PROPOSED DRAFT GLOBAL TECHNICAL REGULATION (GTR)  
on  
PEDESTRIAN PROTECTION.

Transmitted by OICA

This document is a working document circulated for discussion and comments. It does not constitute an OICA proposal as such but is only submitted with the intention to facilitate discussion by the GRSP Informal Group.

Figure 3A. Determination of FL, RL and RWL

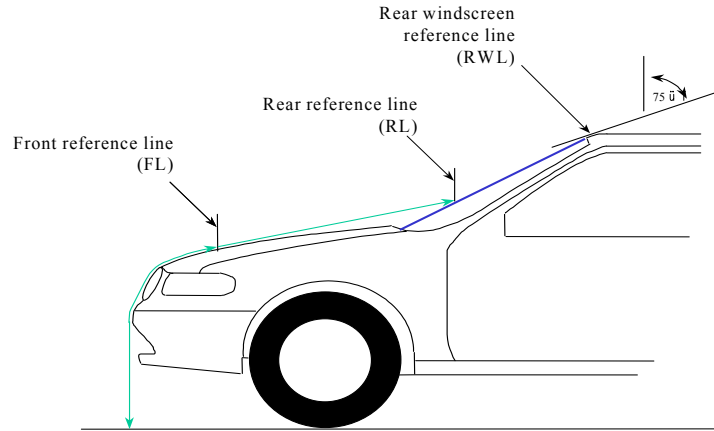
*Note: probably a sphere should be used to define RWL, as foreseen in EU*
